UNITED STATES PATENT AND TRADEMARK OFFICE

Office Action Summary	Application No.	Applicant(s)	
	10/511,070	JONES, STEVEN VICTOR	
	Examiner	Art Unit	
	Katherine W. Mitchell	3677

DETAILED ACTION

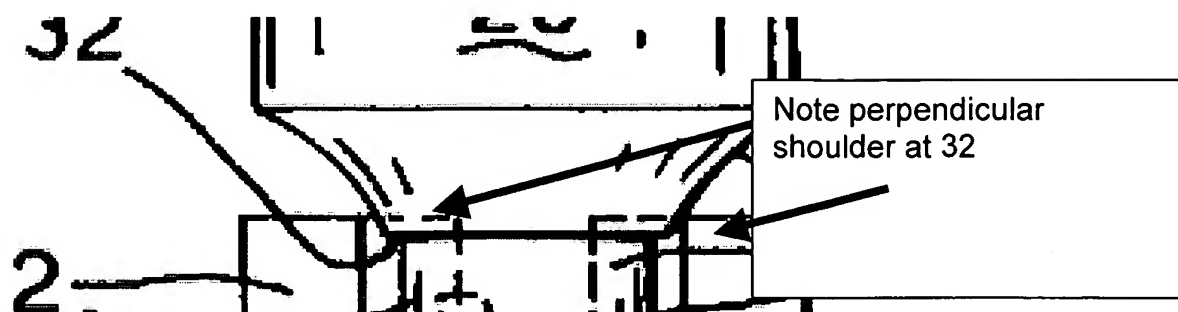
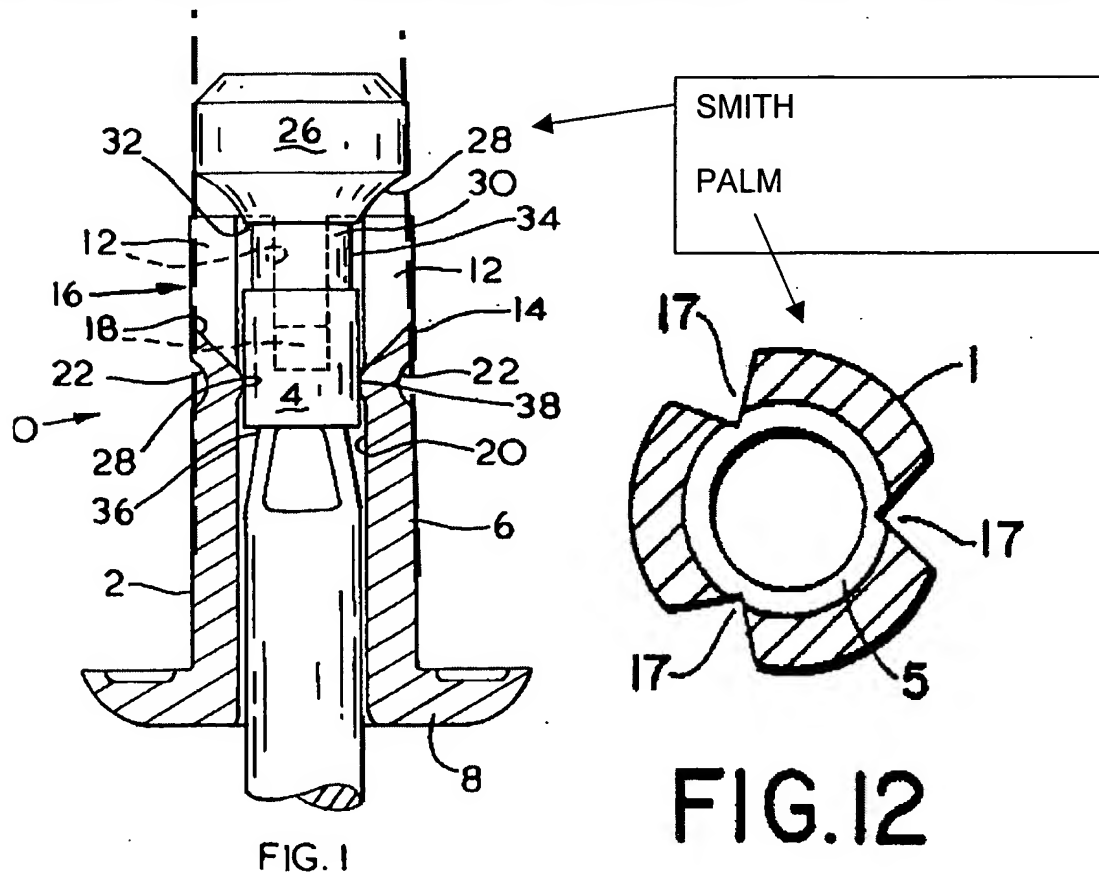
Smith teaches a peel type blind rivet with an elongate tubular body 2 having a shank 6 and preformed head 8 and expandable portion 16 at end remote from head. The expandable portion comprises a plurality of slots 12. There is a mandrel 4 with head 26/28 and stem. The head has a shoulder portion 32 perpendicular to said mandrel stem (Fig 1 below). The maximum head diameter is greater than the ID of the body (page 5 lines 9-11).

Re 2: The opposed end of the shank 8 presents a flat surface perpendicular to said shank axis in Fig 1.

Re claims 3 (off 1 and 2) and 6: Looking at the slope of the bottom edge of the groove, identified as 18 in Fig 1, it is clear the slot increases in length as it extends from an outer surface to an inner surface. (see also page 3 lines 7-10 and page 6 lines 1-4)

Re claim 7-8: Fig 1 shows constant thickness of walls along axial length, and that the external diameter of the body is constant along its axial length

Re claim 9: Reduced diameter section 30 is adjacent said shoulder (Fig 1)

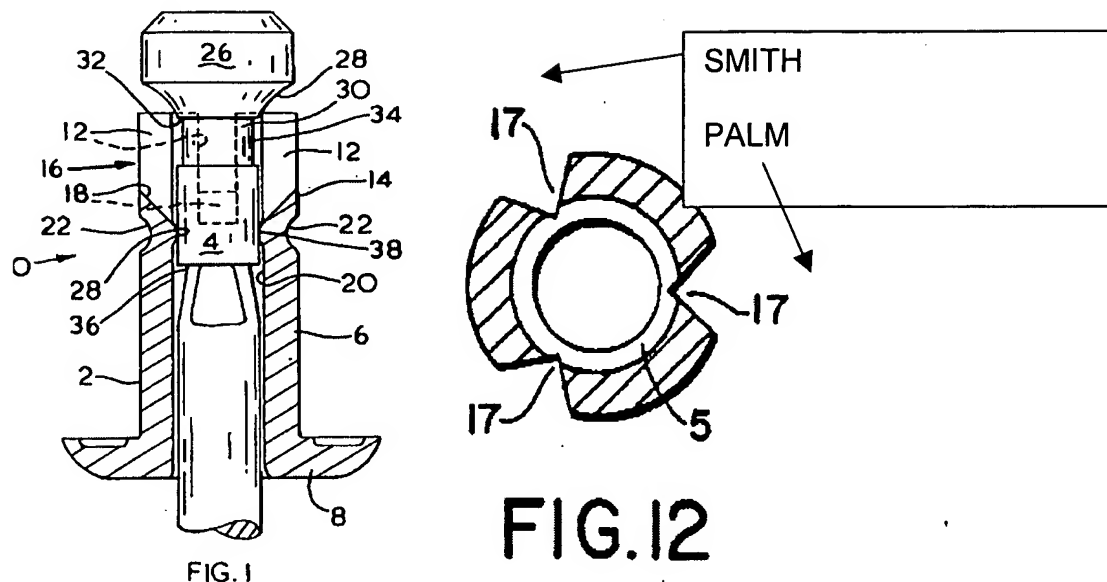
Re claim 10: The (red) dashed lines added by examiner to Fig 1 above show the maximum diameter of the head equal to the OD of the shank.
